Product Change Notice (PCN)

PCN Number: PCN-0456166R

Product(s) Affected: PJ-036CH

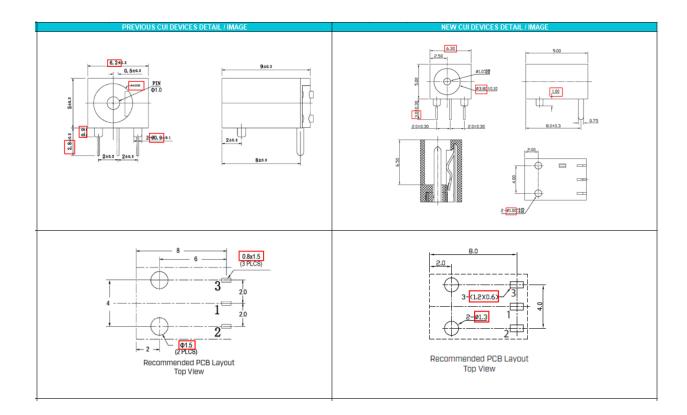
Description of Change: New Factory Location. Product re-engineered for improved manufacturability and production yield. See image below for reference and check CUI Devices website for updated drawing. Cosmetic differences may be visible and not affect the form fit and function of the product.

DESCRIPTION MATERIAL PLATING/COLD center pin brass silver	DESCRIPTION	MATERIAL	PLATING/COLOR
center pin brass silver			
	center pin	brass	silver
terminal 1 brasst=0.25 silver	terminal 1	brass t=0.25	silver
terminal 2 brass <mark>t=0.25 silver</mark>	terminal 2	SUS301 t=0.25	silver
terminal 3 brass t=0.25 silver	terminal 3	brass t=0.25	silver
housing PBT (UL94V-0) black	housing	PPA (UL94V-0)	black
MATING PLUG Jack Insertion Depth 6.4 mm		MATING PLU Jack Insertion Deptr
